Special Bulletin

SP15-331A

AUXILIARY EQUIPMENT DECAL REPLACEMENT

Prevost vehicles

Figure 1

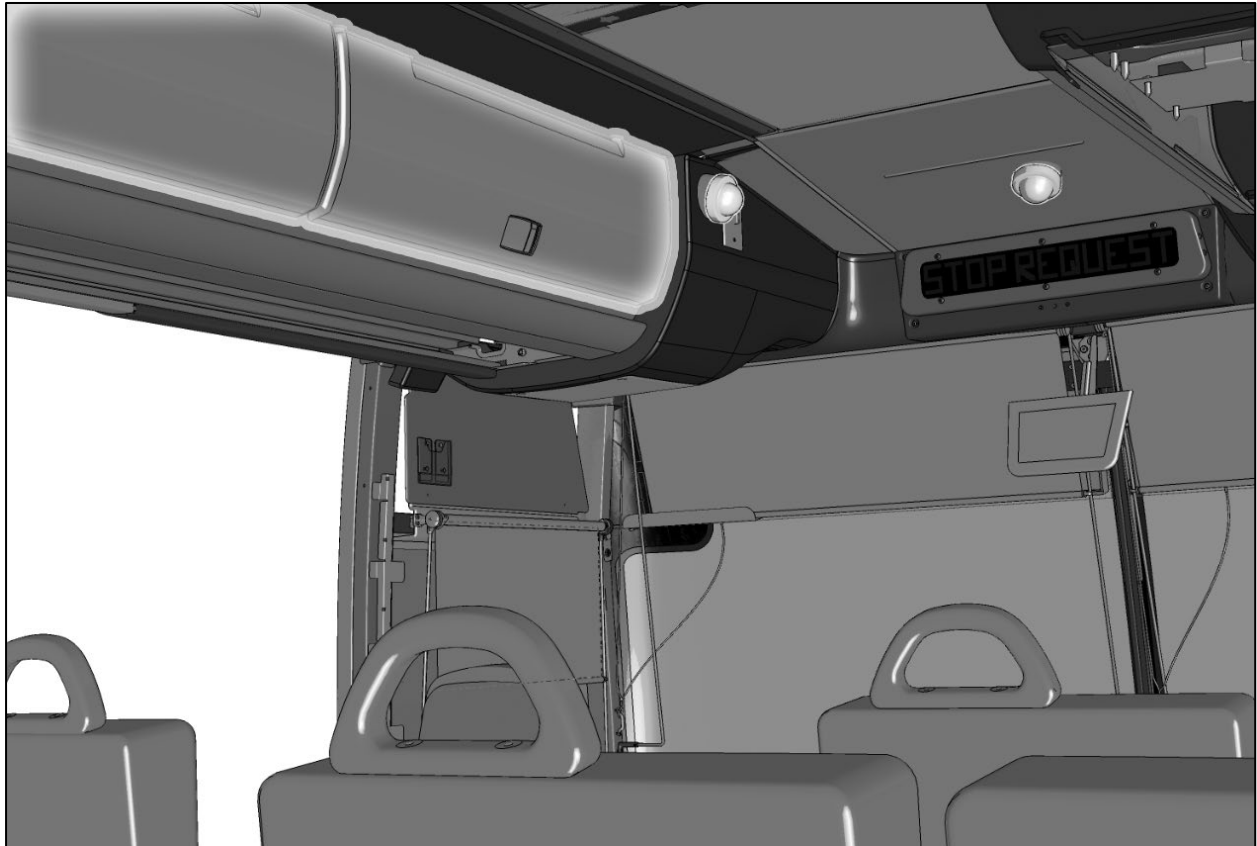
- 1) Locate the road side parcel rack compartment.(Fig. 1)

Figure 2

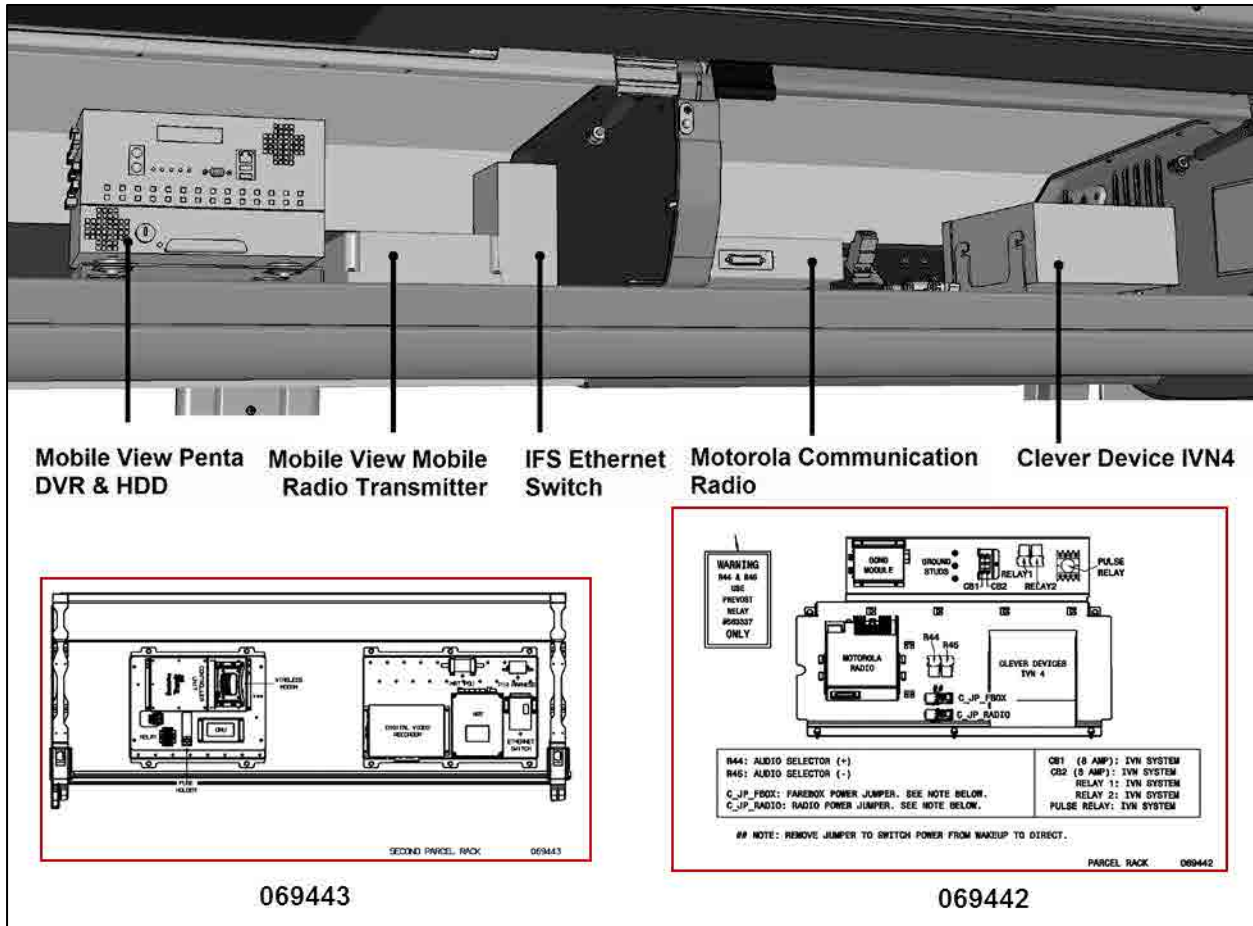
- 2) Remove cable seal. Open the compartment. The decals are located on the inside looking into the compartment.
- 3) Replace decals 069442 for the audio equipment and 069443 the auxiliary equipment. (Fig. 1)
Apply pressure on the decal with a wide plastic spatula or equivalent tool.
